Date: JUNE 17 2016  
Scale: AS NOTED  
SECOND AND THIRD FLOOR POWER PLANS

Revisions:  
06/17/16 100% REVIEW SET  
07/22/16 REVISED PLANS  
07/28/16 ADDENDUM A

Project: LUMINATO  
Newbury Street Portland, Maine

E1.02

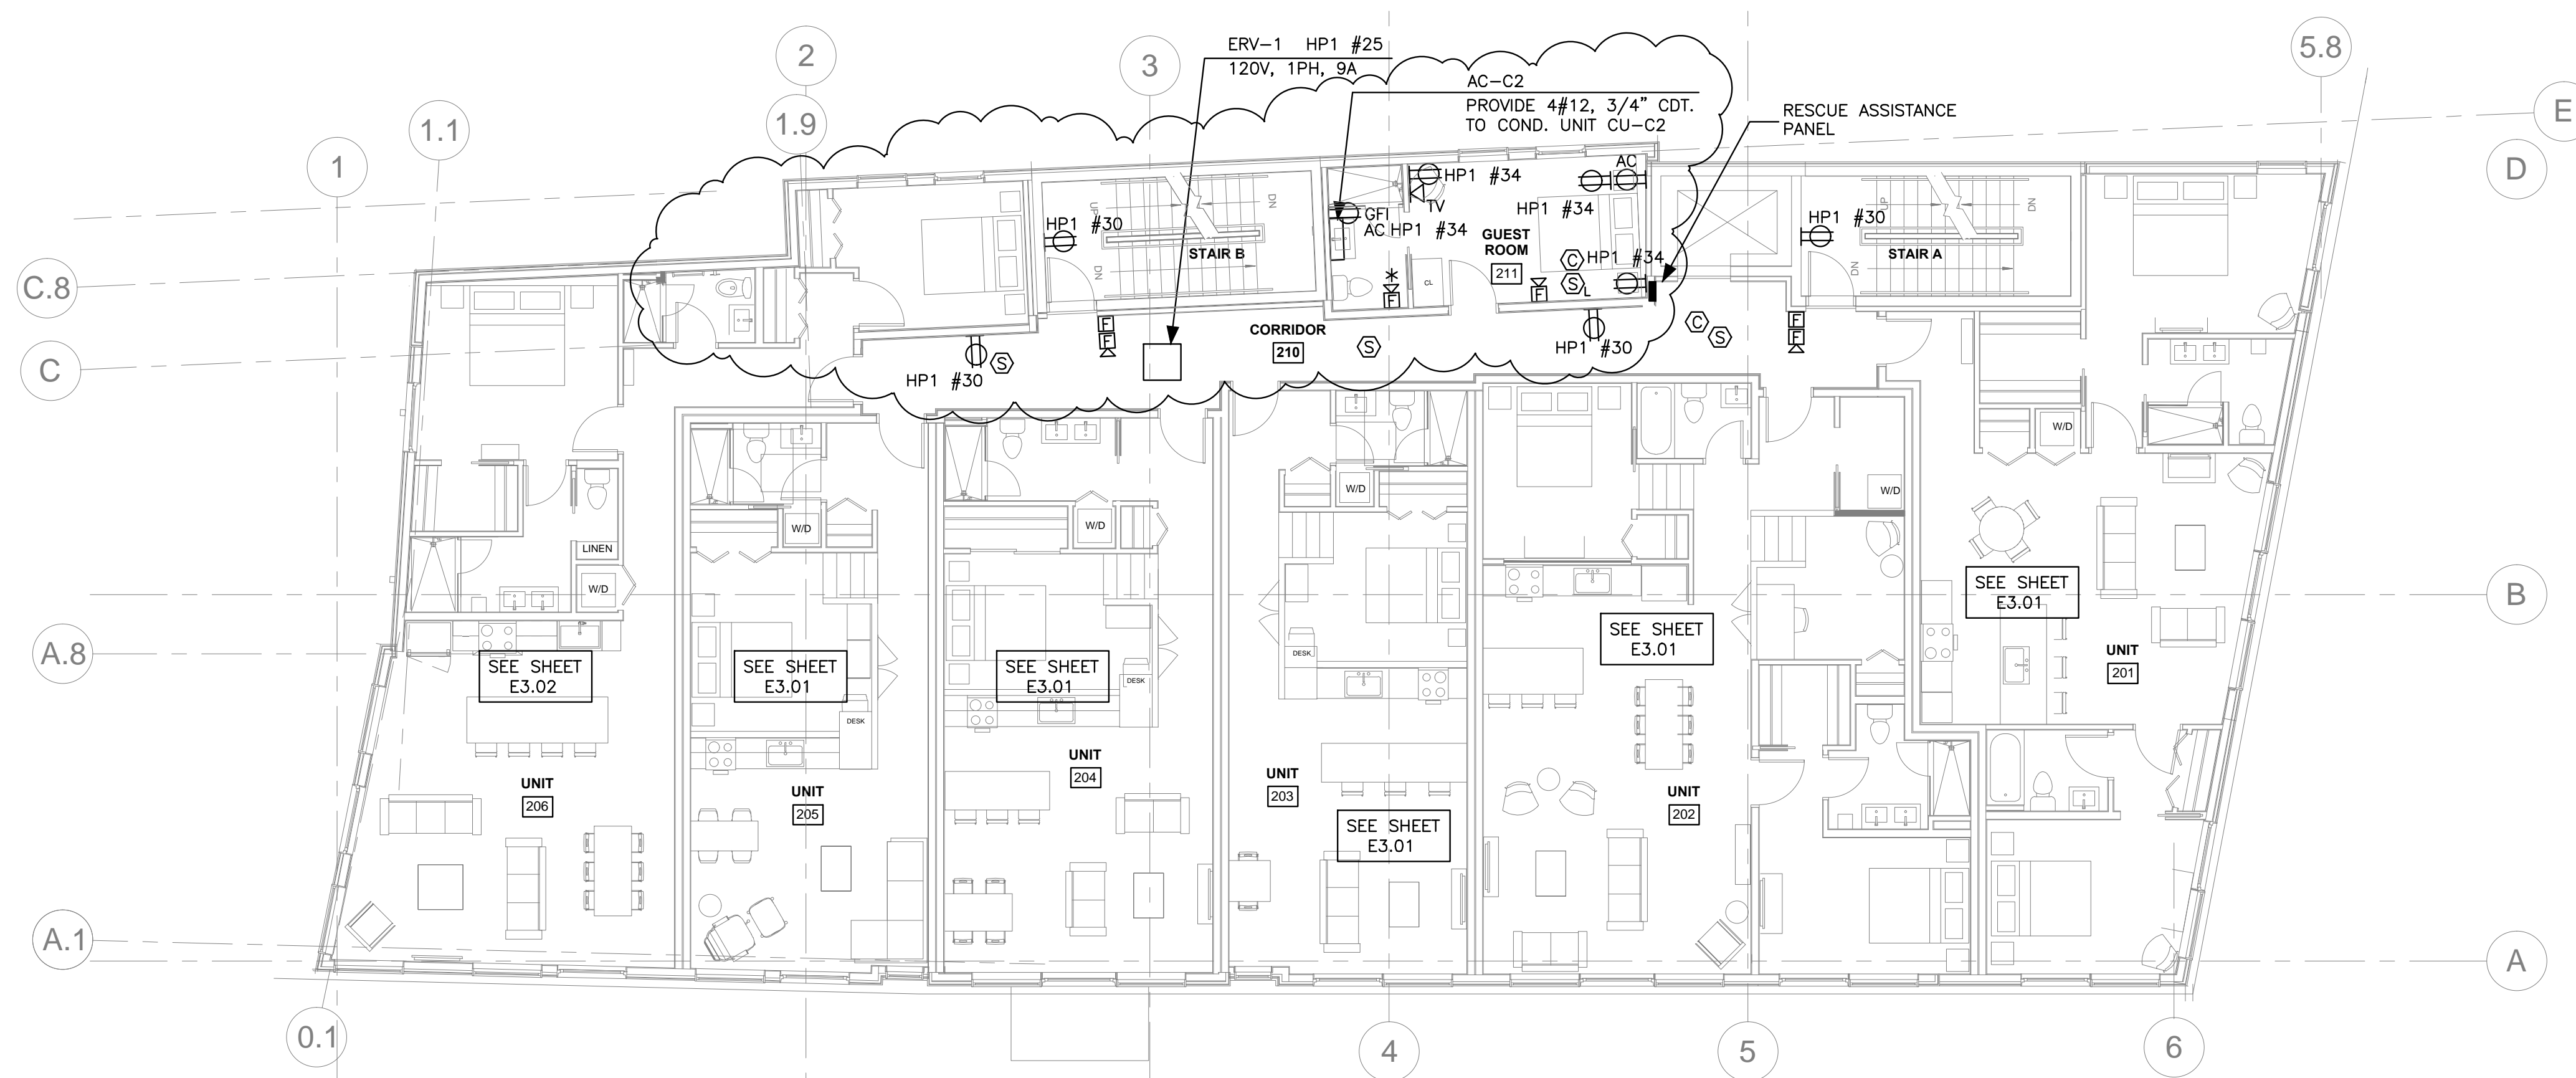
CIRCUIT THE LOCAL SMOKE AND CO DETECTORS IN GUEST ROOM 211 TO PANEL EP1 #3.
